SEPTEMBER 16, 2022

ADDENDUM NO. 02 to the plans and specifications for the MACOMB COUNTY JAIL, VARIOUS PROJECTS PROPOSAL A, B AND C, MT. CLEMENS, MI, Architect's Project No. 221958, dated August 26, 2022

**PROPOSAL A-SANITARY REPLACEMENT**

**PROPOSAL B-BARRIER MESH/SCREEN**

**A0.3B**

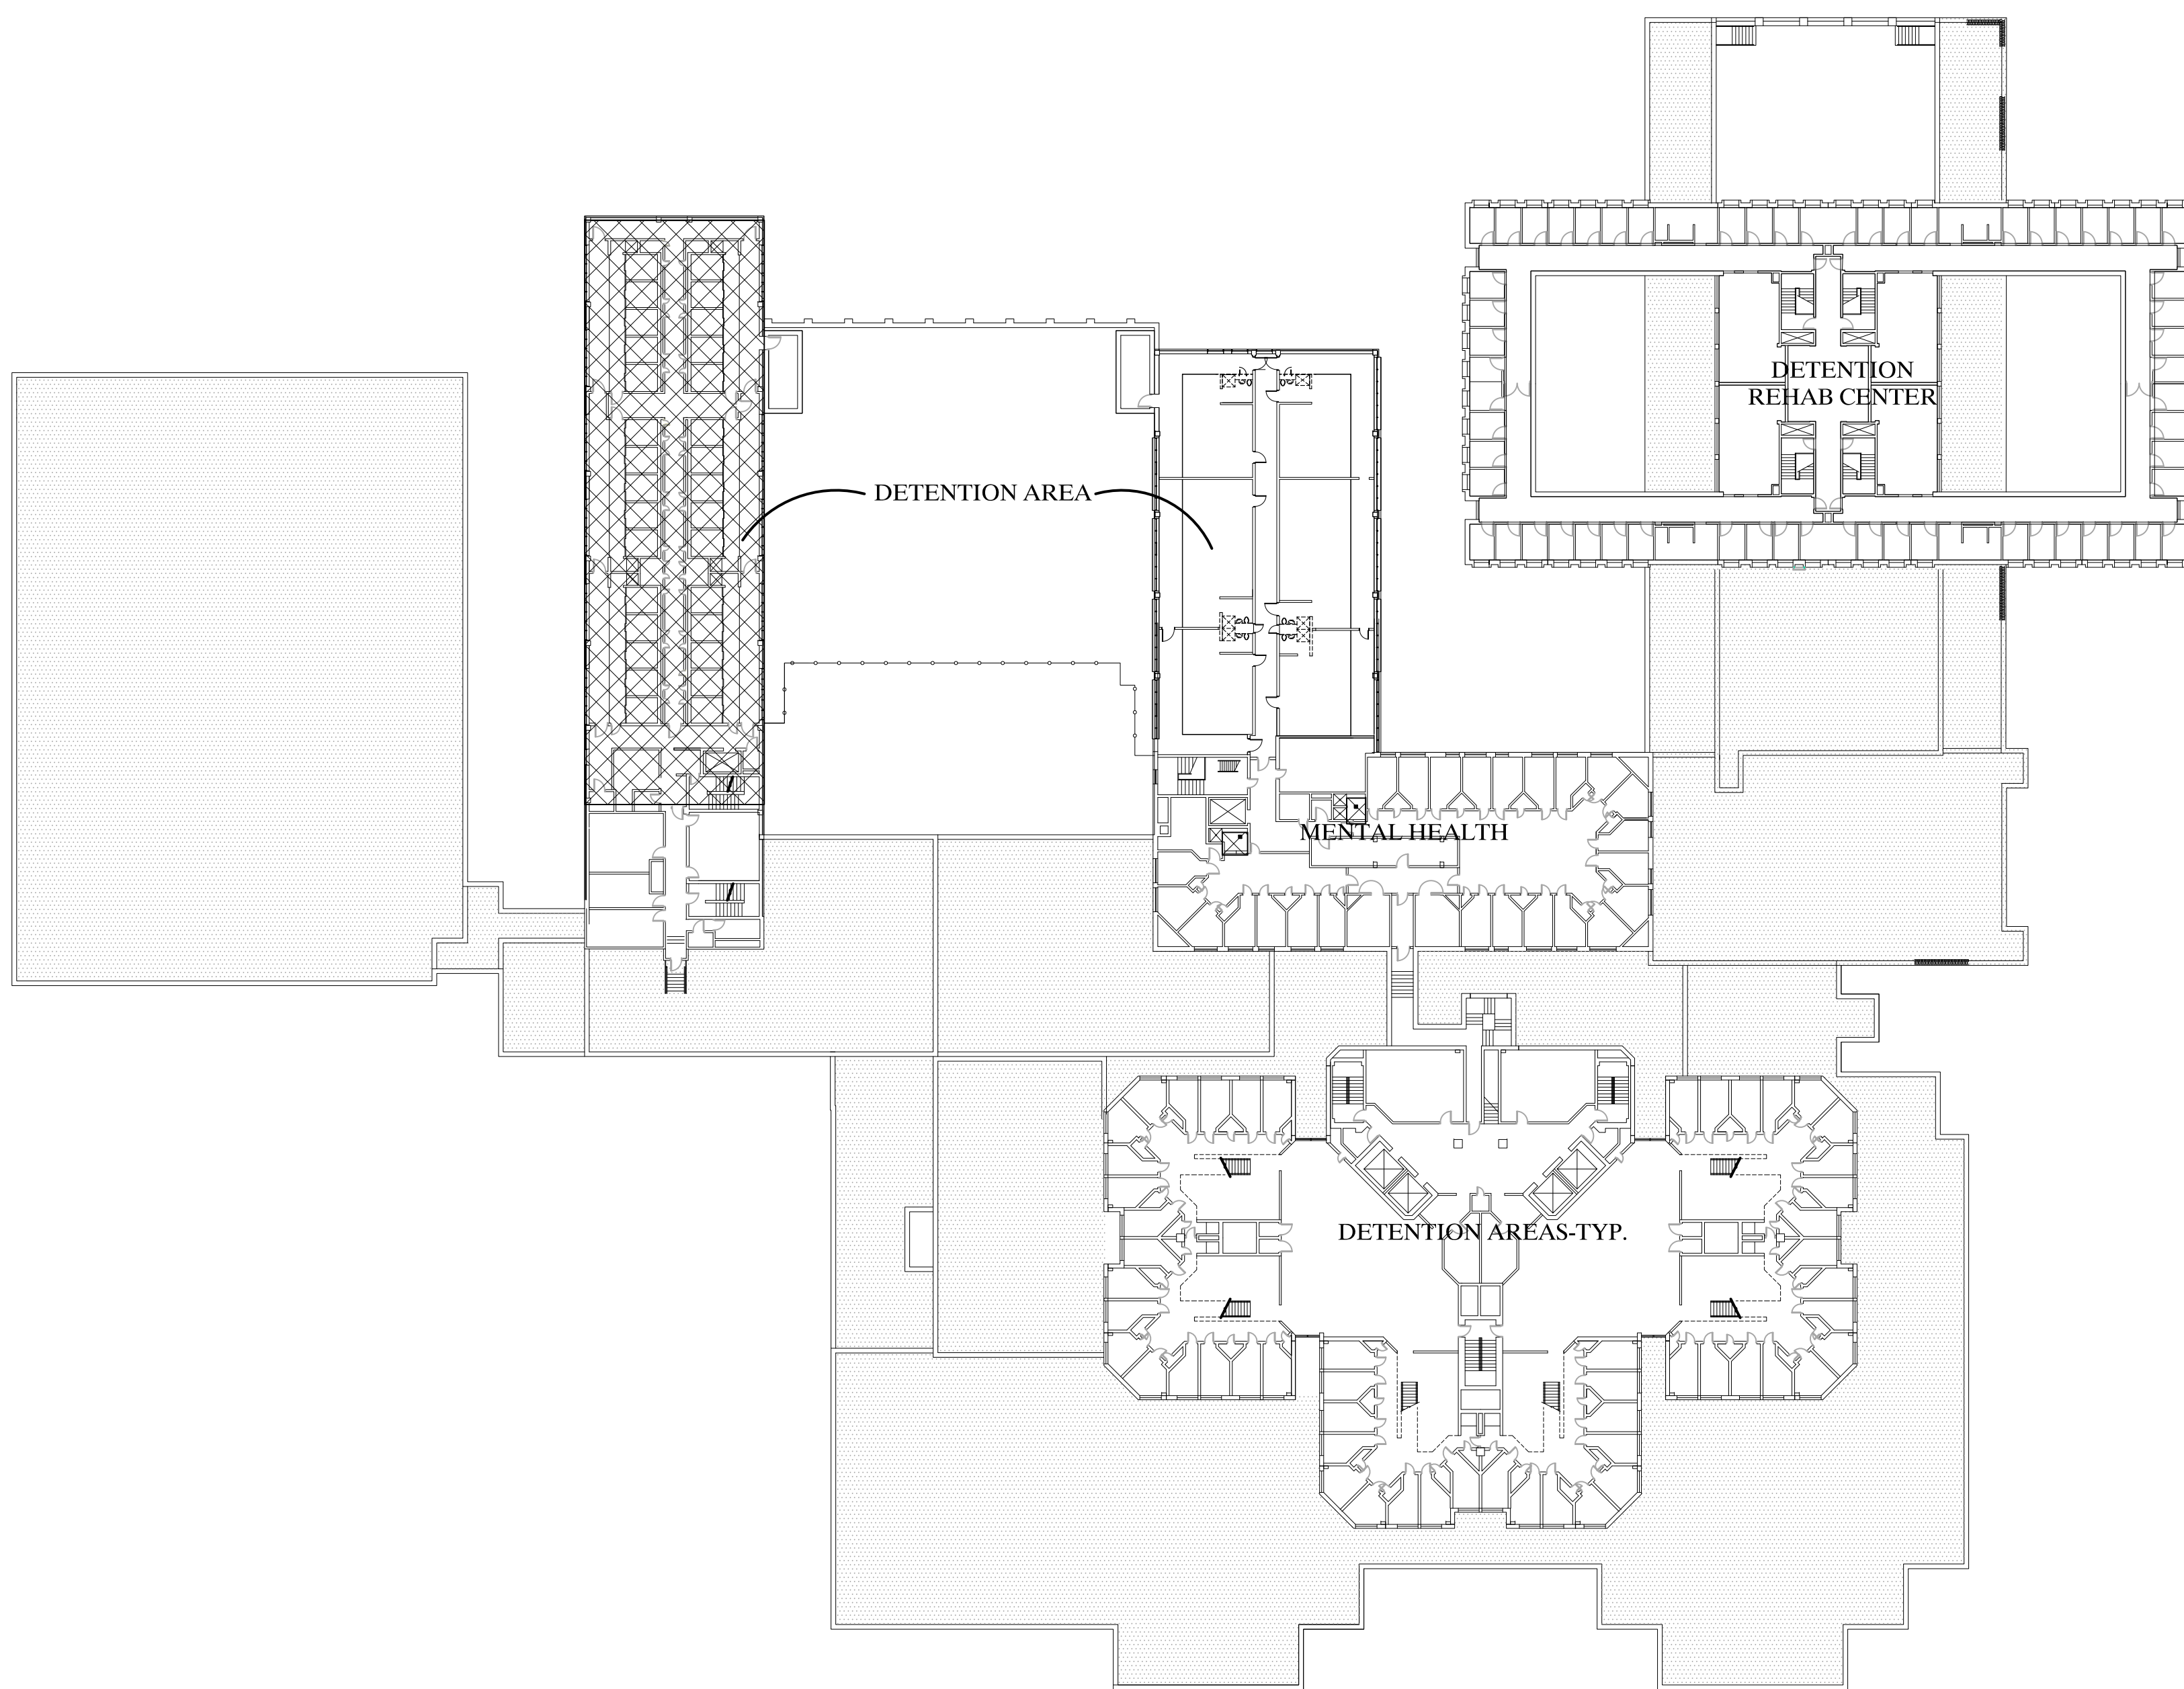
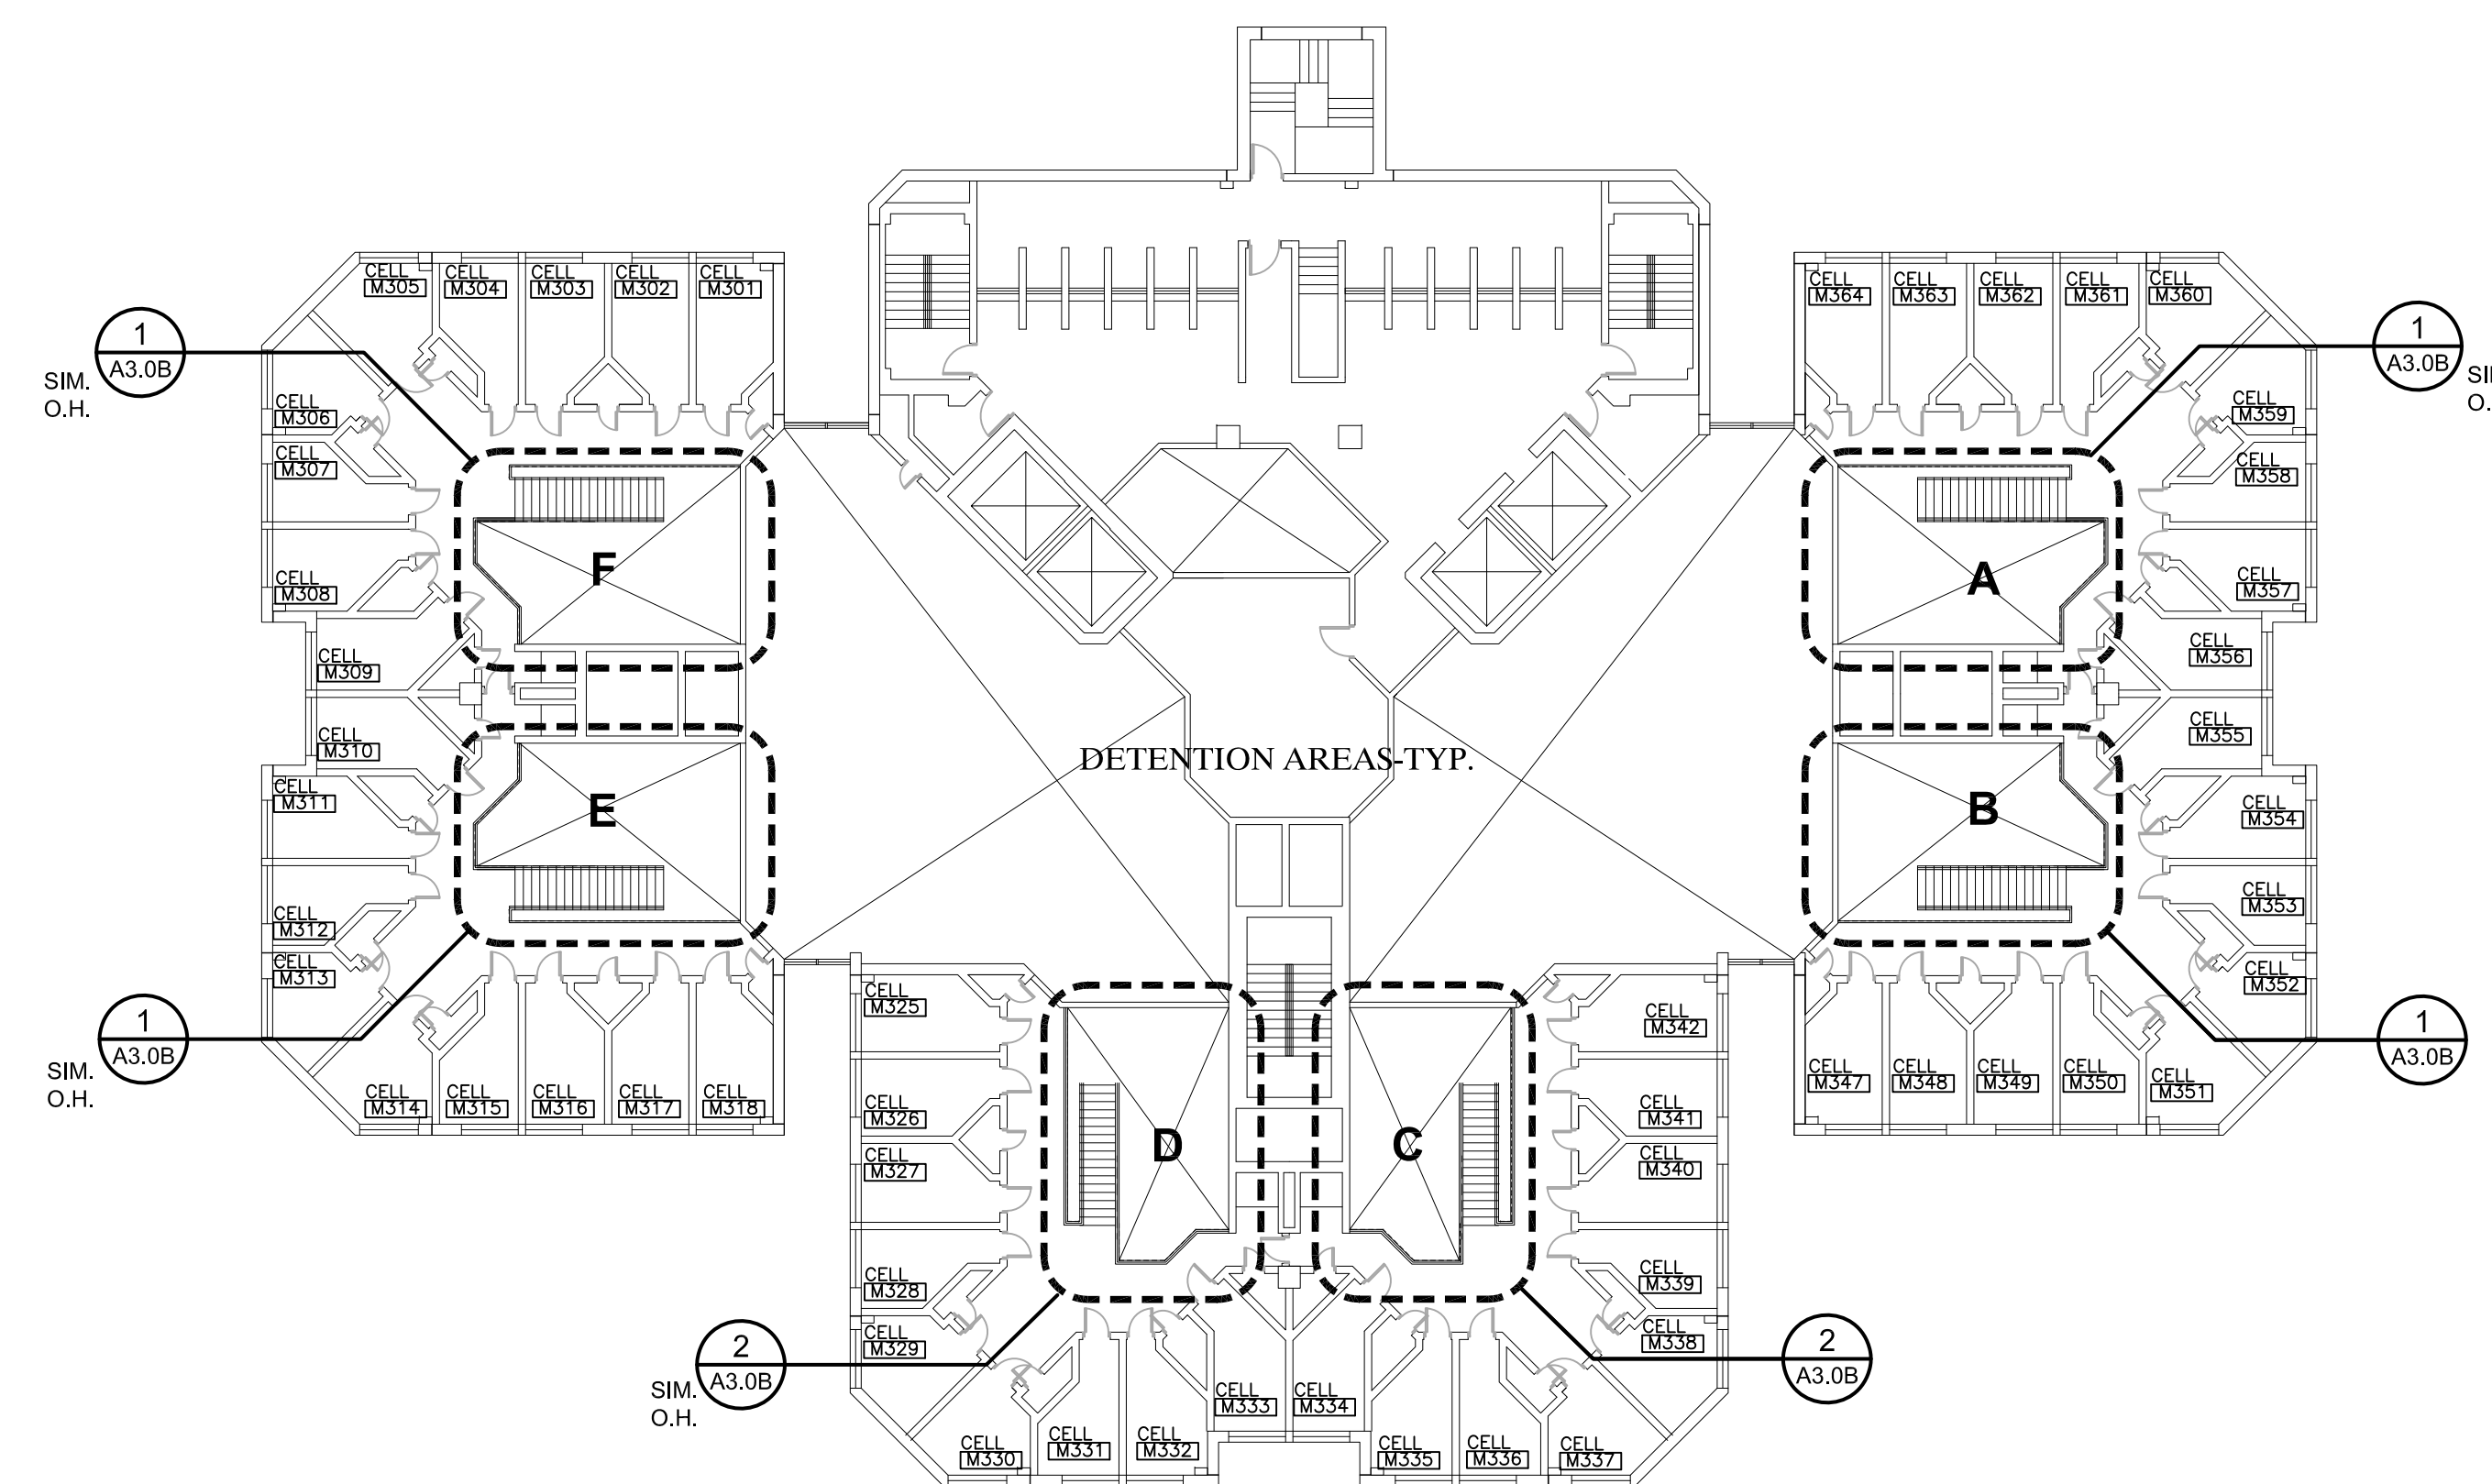
- ITEM NO. A3:** Refer to sheet A03.A(re-issued):
1. Removed callout 1 and 2 from floor plans 4 and 6.
